DEVELOPMENT APPLICATION ASSESSMENT REPORT

Application Number:	DA2021/2053
----------------------------	-------------

Responsible Officer:	Clare Costanzo
Land to be developed (Address):	Lot 26 DP 6238, 52 Burchmore Road MANLY VALE NSW 2093
Proposed Development:	Alterations and additions to a dwelling house and secondary dwelling including a swimming pool
Zoning:	Warringah LEP2011 - Land zoned R2 Low Density Residential
Development Permissible:	Yes
Existing Use Rights:	No
Consent Authority:	Northern Beaches Council
Land and Environment Court Action:	No
Owner:	Kylie Scheibye Morten Scheibye
Applicant:	Morten Scheibye

Figure 1: Amended plan removing access to the secondary dwelling from the proposed internal stairs.

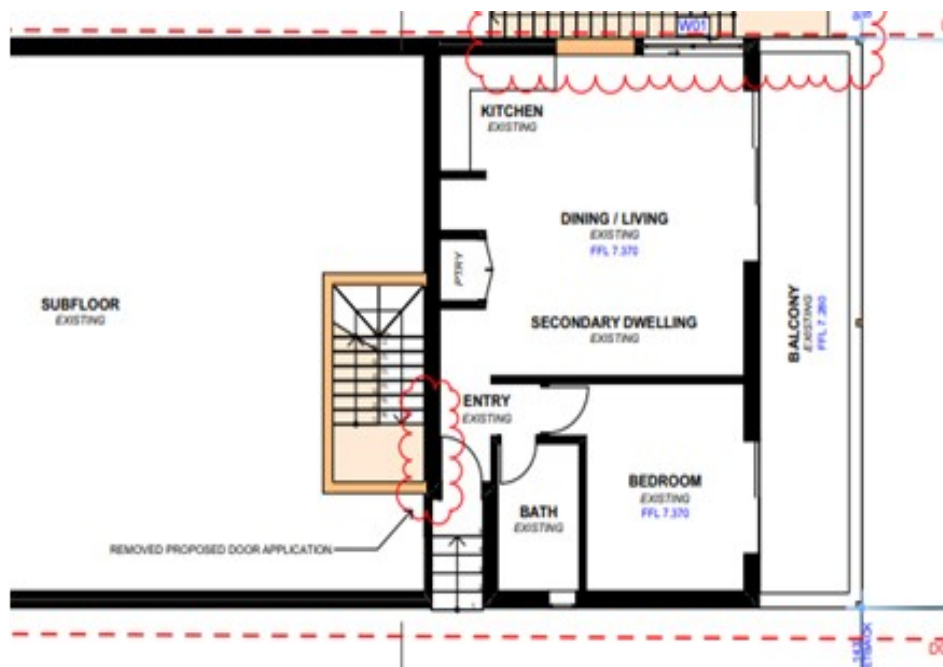
Concern was raised that the basement level was connected to the existing secondary dwelling via the new internal stairs and approval of this would essentially result in a two storey secondary dwelling larger than the permissible size within the Warringah Local Environmental Plan 2011. Council requested the applicant to remove access from the new internal stairs to the existing secondary dwelling, see Figure 1 below. A condition has also been included as part of the development consent restricting the basement level to be used as separate habitation to the primary dwelling.

Figure 2: Proposed Long Section with non compliance indicated above the top orange dash

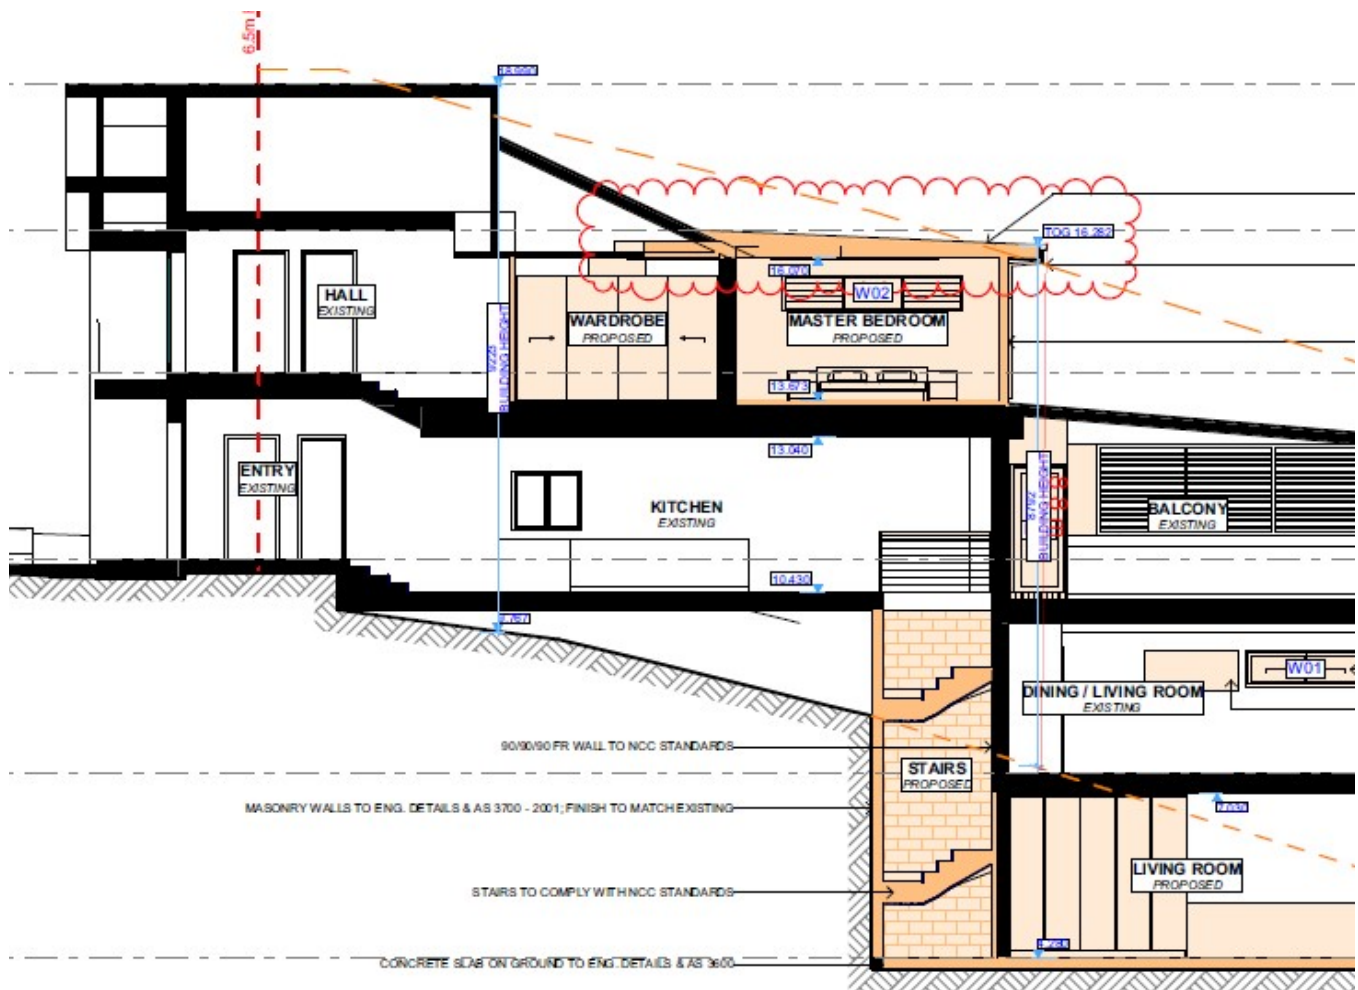
The applicant's written request notes the height exceedance is a result of the steep sloping topography of the site and the proposed rear addition has stepped to follow the site topography. The applicant argues that the height of the dwelling is unchanged and compliant when viewed from Burchmore Road.

The variation is a result of the enclosure of an existing balcony to provide for residential floor space. The applicant argues there will be no unreasonable bulk or scale when viewed from Burchmore Road and the breach will not result in any adverse environmental or amenity impacts. The height breach is a result of a small portion of the new roof eave (See Figure 2).

Following amendments to the original architectural plans to reduce the height by 300mm by amendments to the roof form, Council is satisfied the development better responds to the site constraints and the sloping topography of the site. Additionally, the height variation is not expected to result in any unreasonable amenity impacts as a result of the breach. The breach is limited to the north eastern corner of the proposed new bedroom roof eave and is considered to meet the objectives of the height control.
